ADA Compliance Program

Clark County Facilities Transition Plan
Clark County Center for Community Health – 3rd and 4th Floors

Date of Survey: May 8, 2006
Conducted by:

Fig. 307.2
Limits of Protruding Objects

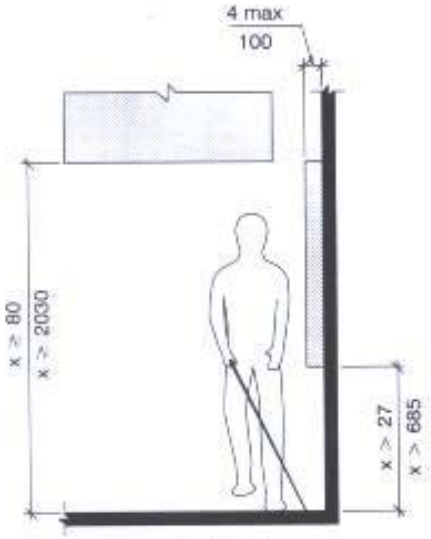
Item: Drinking Fountain – 3rd Floor Lobby

ANSI 307.2 Protrusion Limits.

Objects with leading edges more than 27 inches and not more than 80 inches above the floor shall protrude 4 inches maximum horizontally into the circulation path.
The drinking fountain shown protrudes 11 inches and the height shown is 32 3/8 inches.

- Fountains should be recessed into an alcove.
- Barrier's constructed around fountains
